CITY OF DULUTH
Planning Division

STAFF REPORT

File Number	PL 13-164	Contact	Jenn Reed Moses, jmoses@duluthmn.gov	
Application Type	Variance	Planning Commission Date	January 14, 2014	
Deadline for Action	Application Date	December 13, 2013	60 Days	February 11, 2014
	Date Extension Letter Mailed	December 20, 2013	120 Days	April 12, 2014
Location of Subject	609 W Central Entrance			
Applicant	Members Cooperative Credit Union	Contact	218-625-8511, heikt@membersccu.org	
Agent	George Janssen	Contact	gjanssen@marketpointecre.com	
Legal Description	010-3182-00010			
Site Visit Date	N/A	Sign Notice Date	January 6, 2014	
Neighbor Letter Date	December 31, 2013	Number of Letters Sent	11

The applicant is requesting a variance from the maximum parking requirements to allow 19 spaces instead of the maximum 17 allowed by the UDC.

revision/issue
SITE PLAN
 sheet number
1 of 3

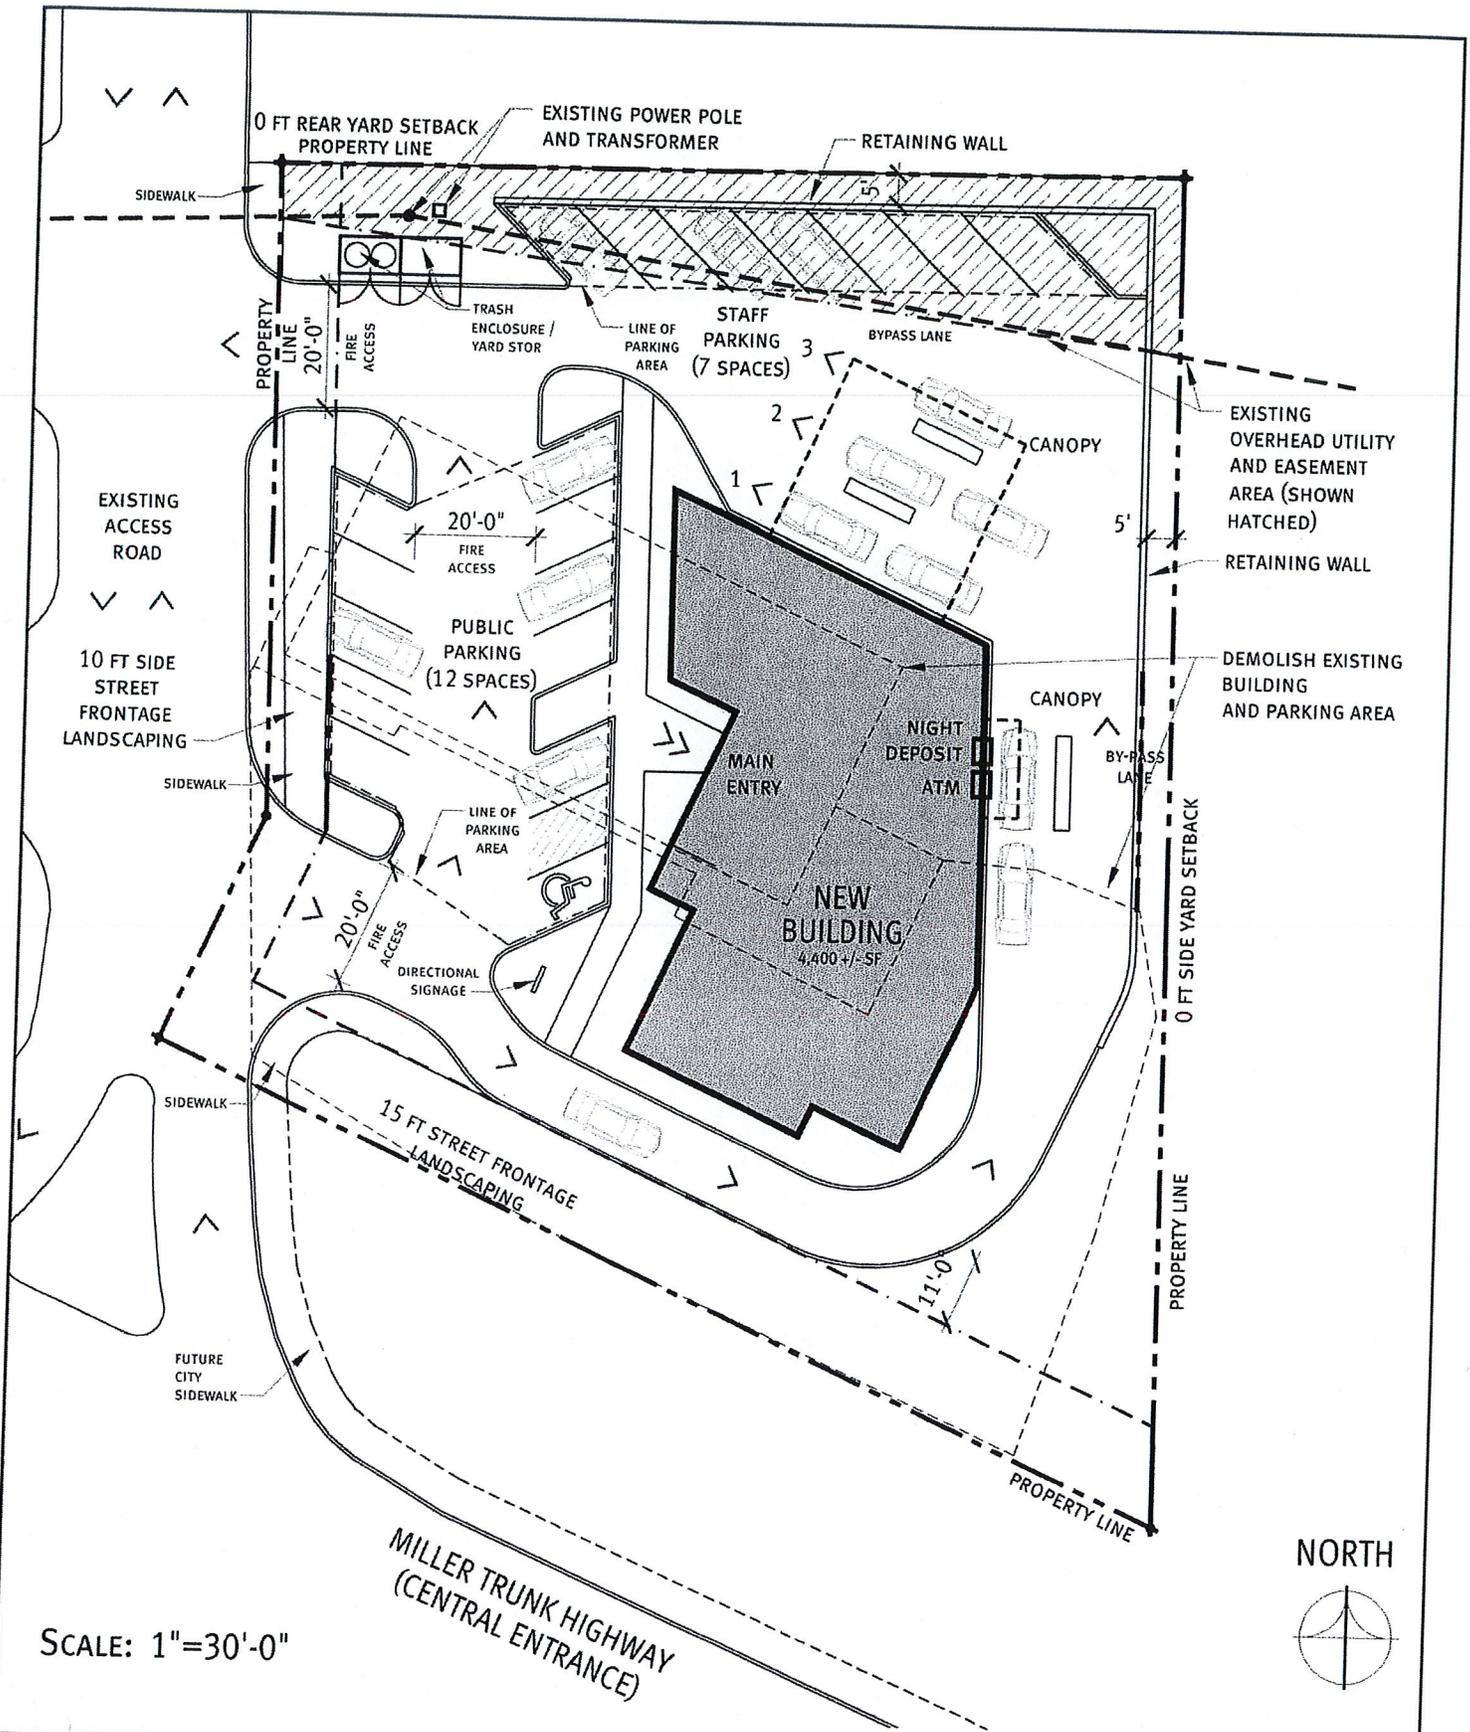
- 1.) Applicant is requesting a variance to provide more than allowed parking maximum of 150%. The UDC requires 2.5 parking spaces per 1,000 sq. ft., resulting in a minimum requirement of 11 spaces and a maximum allowed of 17 spaces. Applicant is requesting a total of 19 parking spaces for their site, 2 more than allowed by zoning regulations.

- 2.) Sec. 50-37.9.G. states that maximum parking variances may not exceed 175% of the required minimum. For this project, 175% of the minimum is 19 spaces, which is what the applicant is requesting.

- 3.) Applicant is proposing to use the property in a reasonable manner. Requested variance will not alter the essential character of the area, as it is a busy commercial area with surface parking lots.

- 4.) The state statutes regarding variances require applicant to demonstrate practical difficulty. The presence of neighboring areas with large parking lots does not contribute to practical difficulty for this site. Need for relief is not due to circumstances unique to this property. The lot does not have wetland, slope, bedrock, or other topographical conditions that present a practical difficulty.

- 5.) If the variance was denied, it would not deprive the property owner of a substantial property right. Applicant is able to use it as a bank with two fewer parking spaces.

Staff recommends Planning Commission deny the requested variance, for the following reasons:

- 1.) Applicant has not demonstrated practical difficulty that is due to exceptional narrowness, shallowness, or shape of the applicant's property, or because of exceptional topographic or other conditions related to the property.
- 2.) The special circumstances or conditions are not peculiar to such property or immediately adjoining property.
- 3.) The relief is not necessary for the preservation and enjoyment of a substantial property right.
